## PLANNING COMMISSION MEETING STAFF REPORT

**NAME OF PROJECT:** Shangri-La Subdivision

**AGENDA ITEM:** Preliminary/Final Approval

### **ITEM: 4**

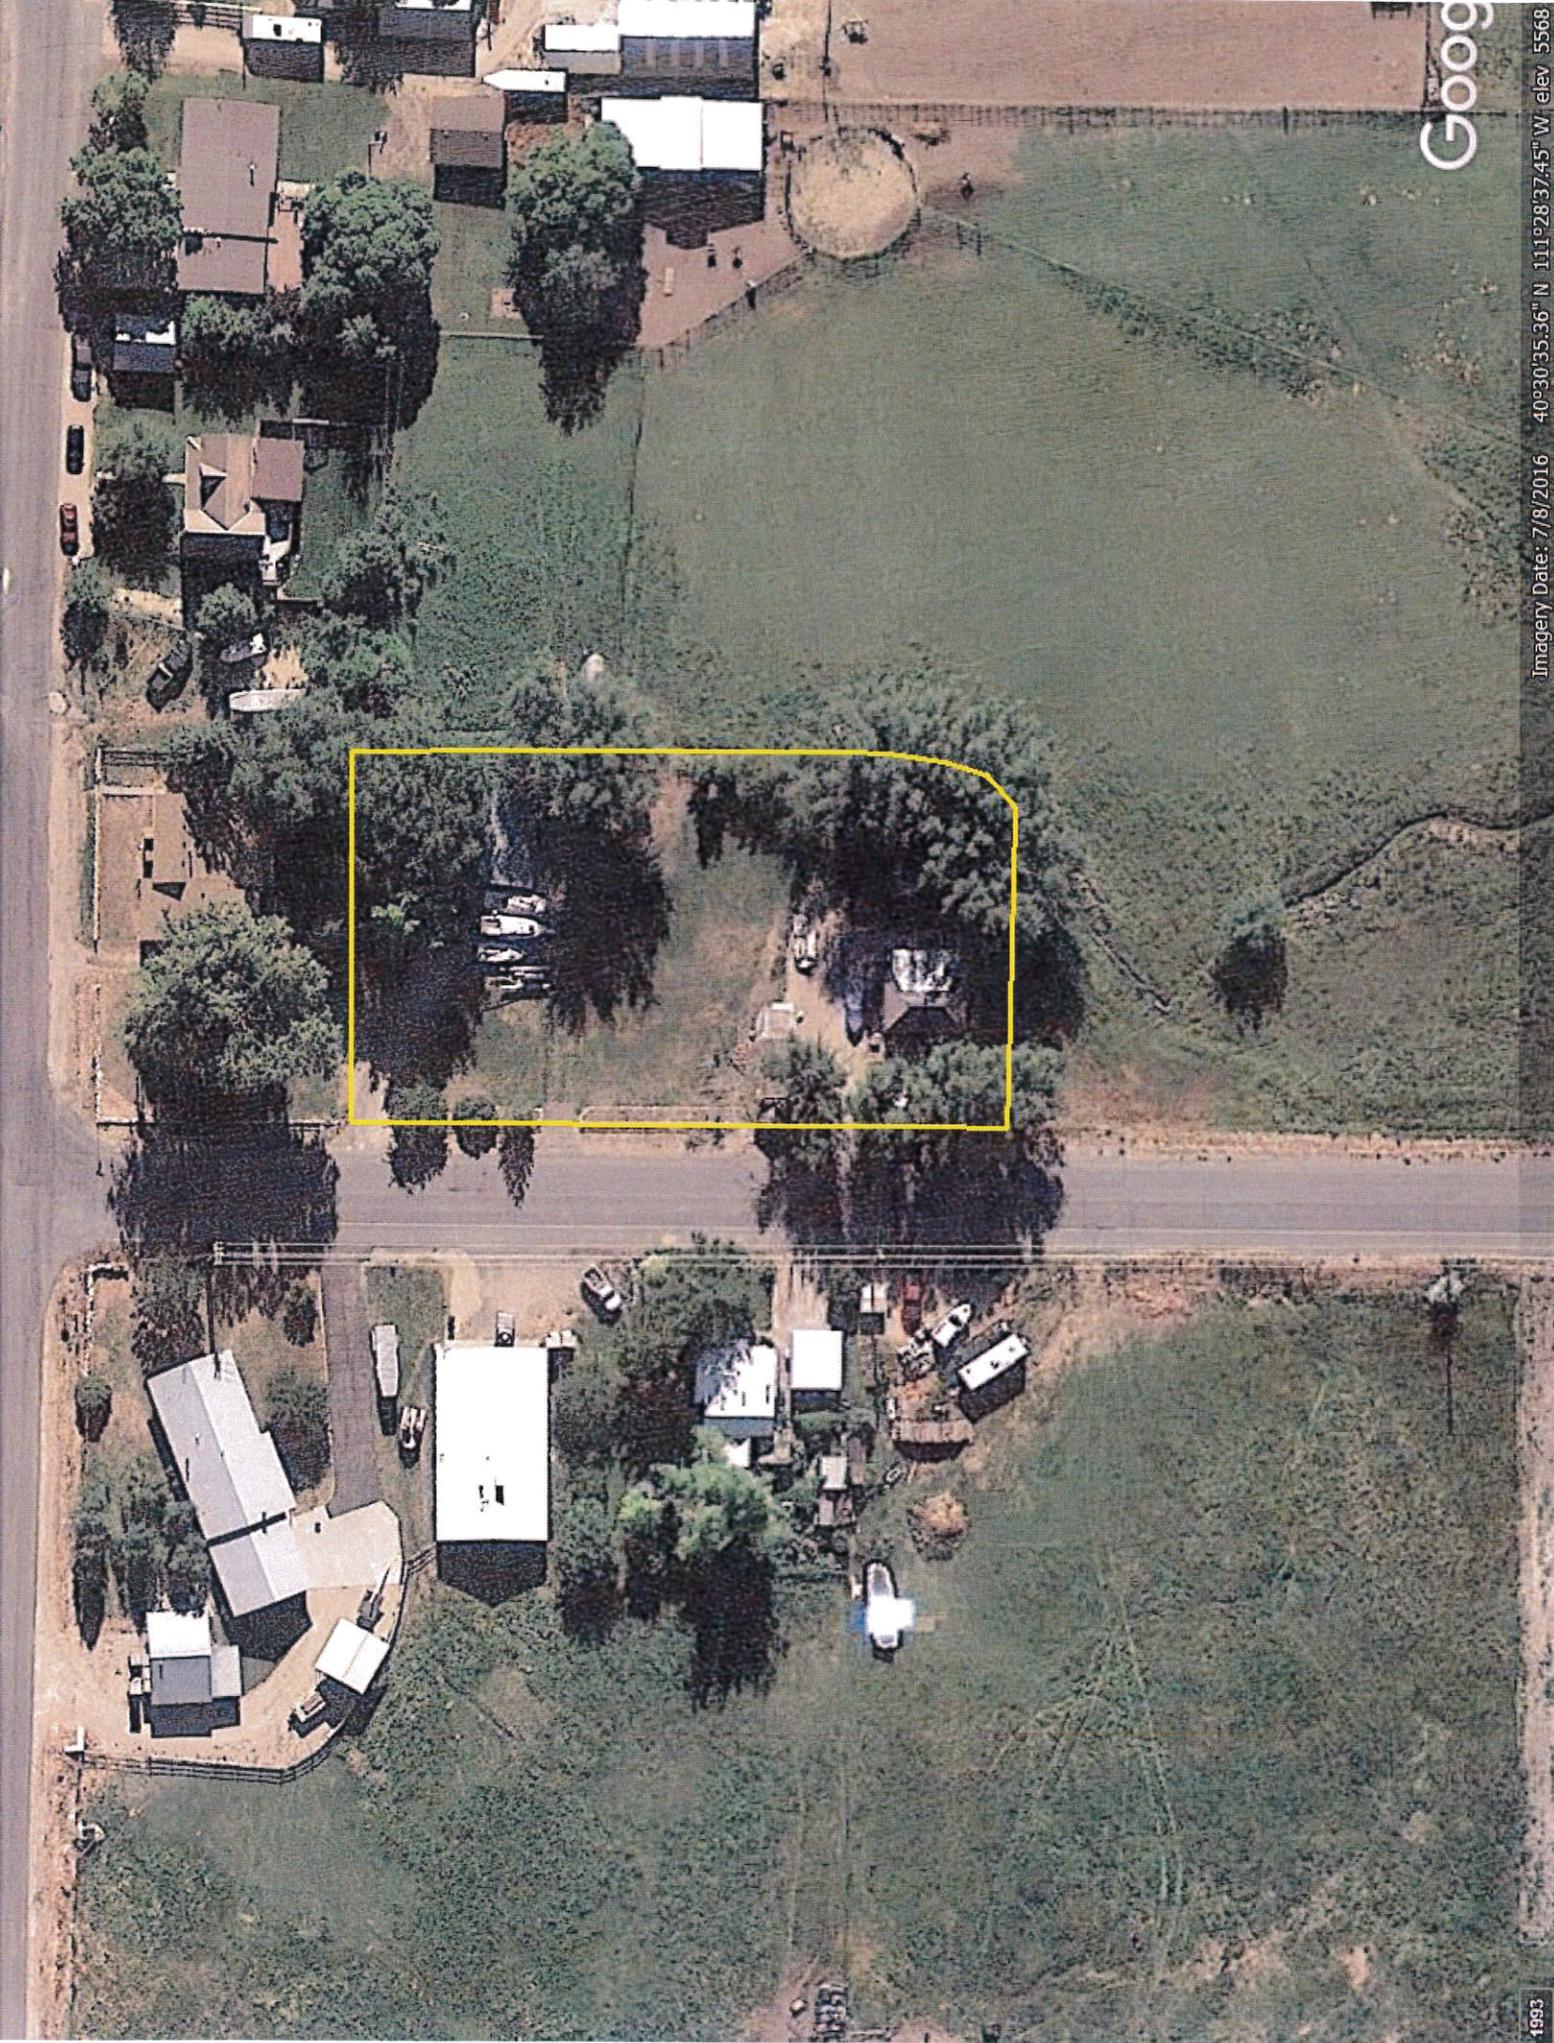
*Access* – Access both lots is from Center Street which is a collector road. Since 250 West is a collector road and traffic will only increase over time on this road, the City should consider requiring a turnaround or hammerhead for the driveway on the lot 2. Lot 1 currently does have a turnaround as part of the driveway.

- A note will be included on the plat that will limit a single-family dwelling to both lots.
- A driveway turnaround or hammerhead is required on lot 2.
